Advisory Notice for Titan T-51 Mustang Aircraft

March 4, 2009

Service recommended before any further flights

MATERIAL		DETAIL NAME AS NOTED	
DRAWN B. HODGKINSON	DATE 8-25-03	SCALE 1/4"=1"	PART NO. AS NOTED
CHECKED	DATE	ASSEMBLY NAME TAILWHEEL INSTALLATION INSTRUCTIONAL	
APPROVED	DATE	PART NO.	DRAWING NO.
		DRAWING NO. B T51-03-INS-0816-E

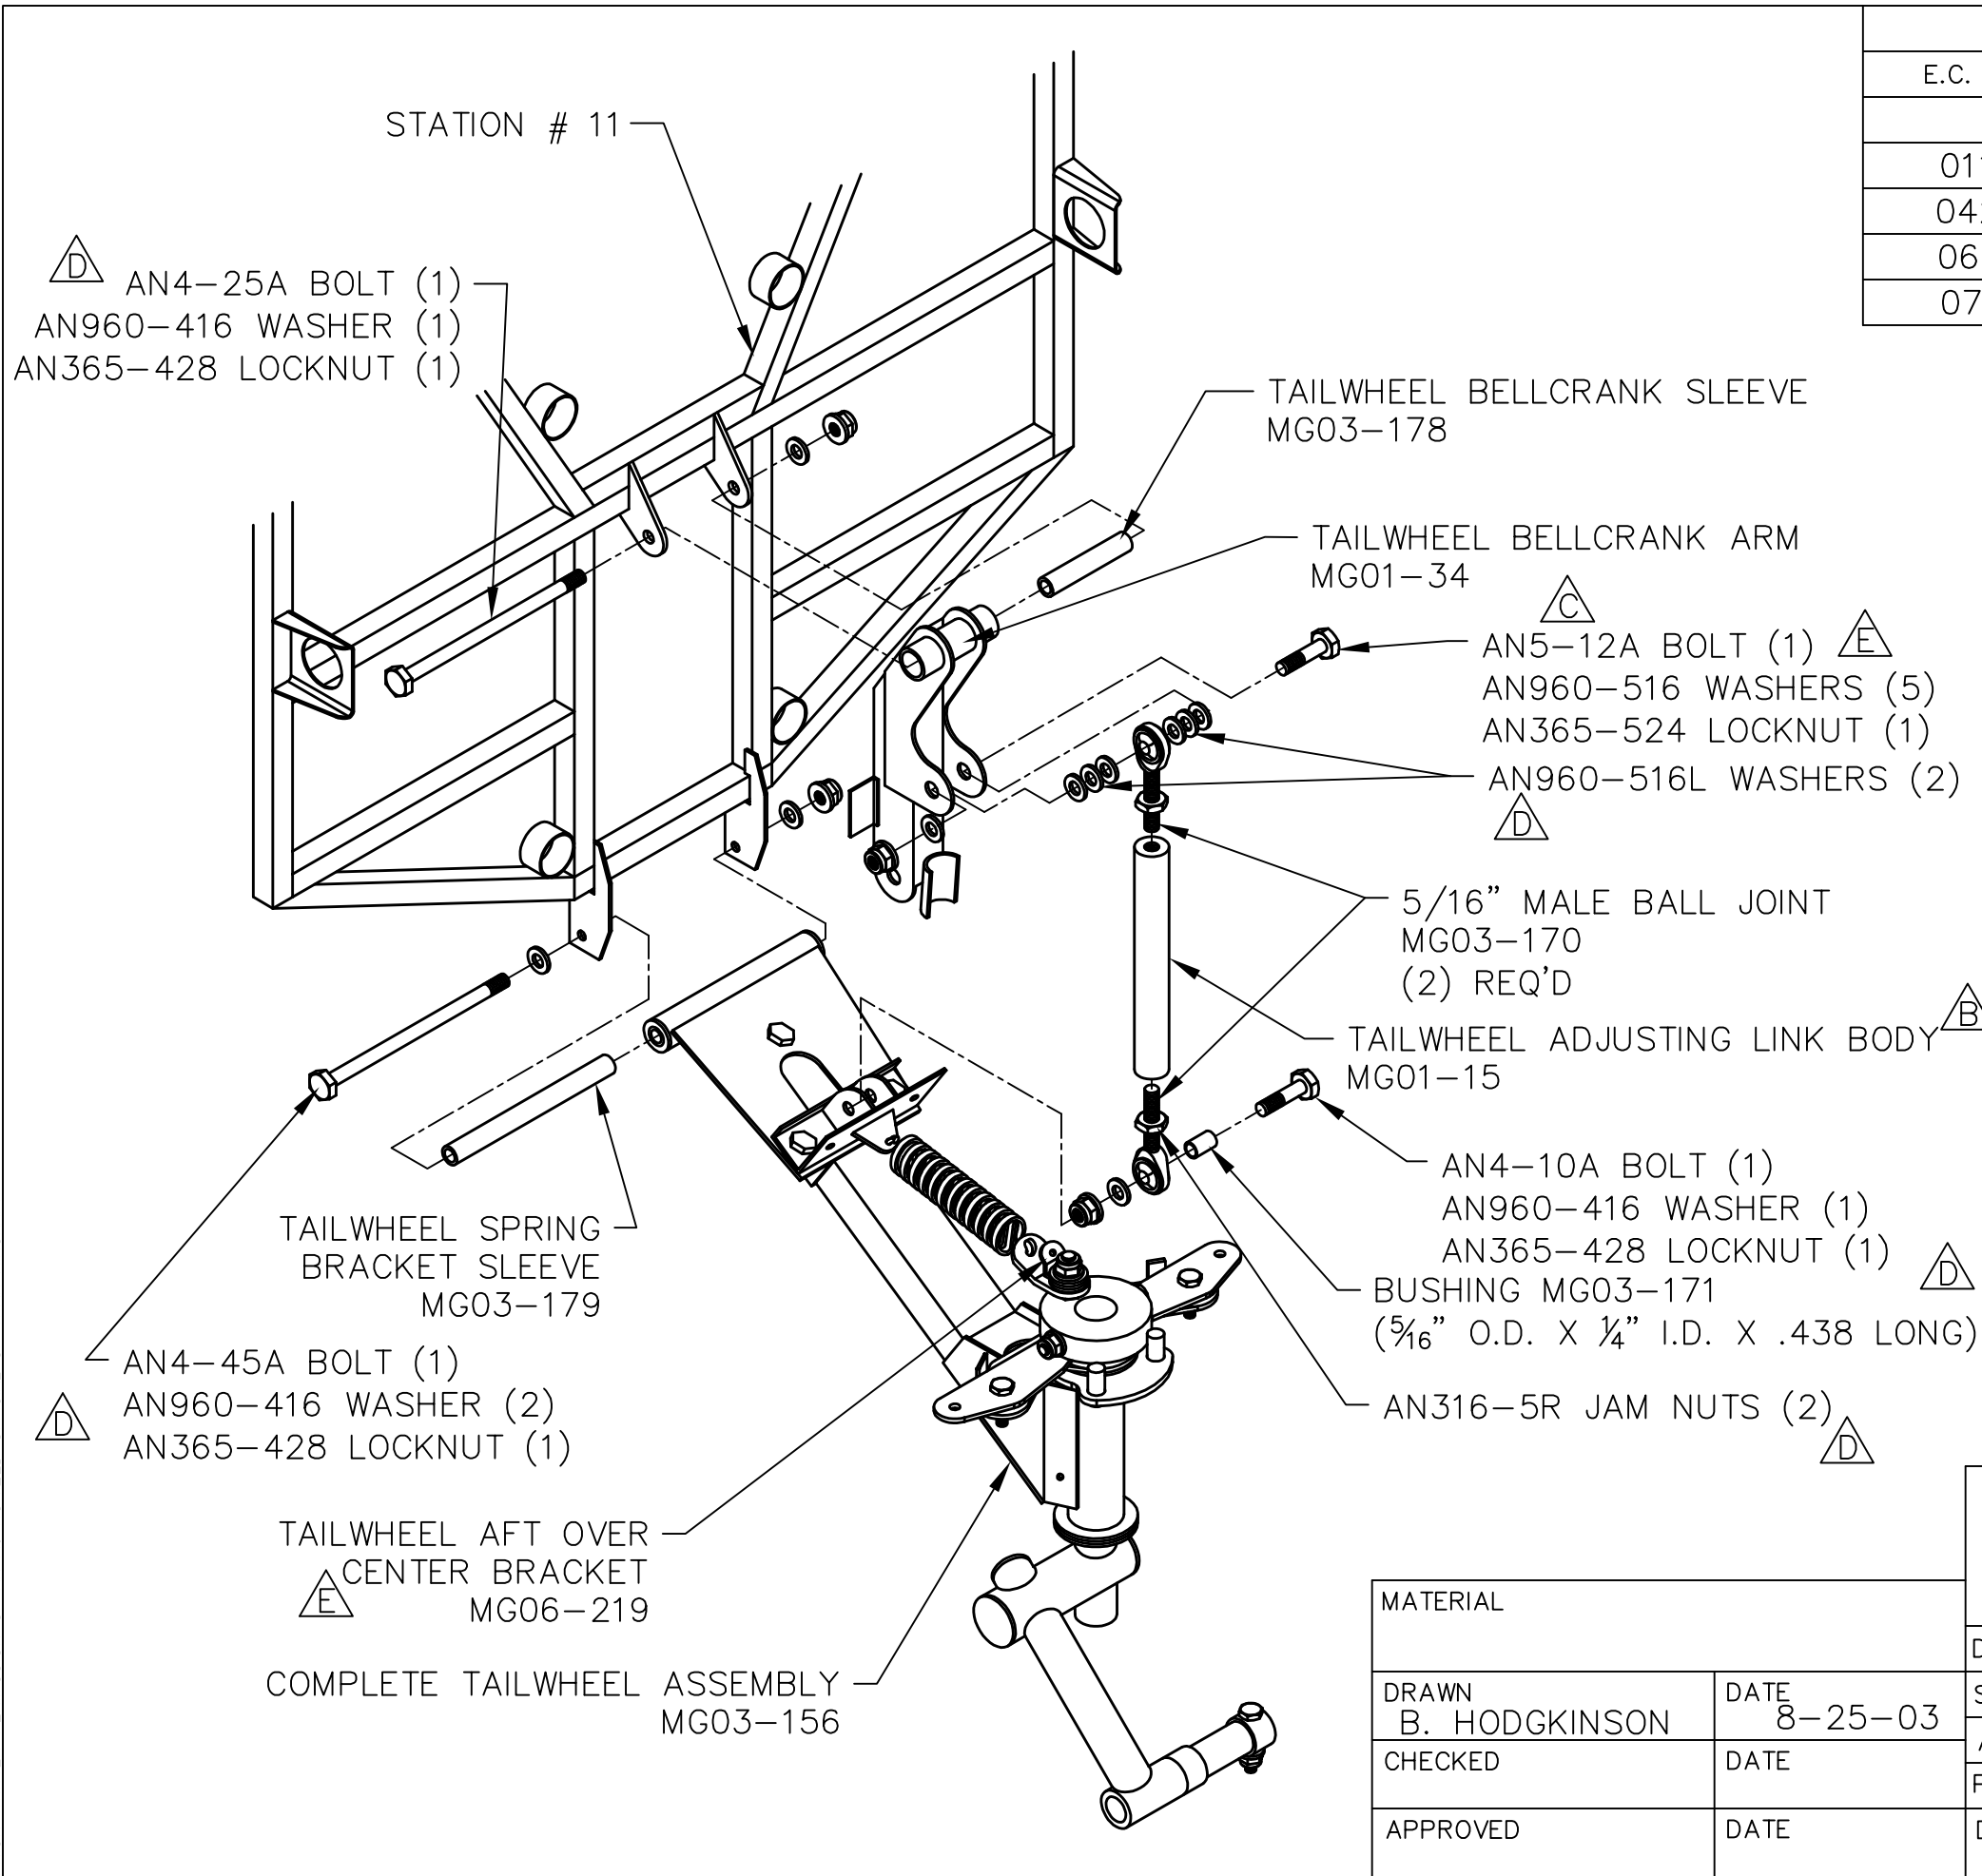
An aircraft, with approximately 150 hours of service on a rough grass field, was found to have the support tube at station #11 twisted. This caused the tailwheel to retract while the aircraft was landing, resulting in damage to the gear doors.

Using the aft baggage compartment opening, inspect station #11 to see if there is a second tube welded in place above the over center support bracket tube, as shown on the attached drawing number T51-03-INS-0816-E. If there a second tube no further action is required, if not, see below.
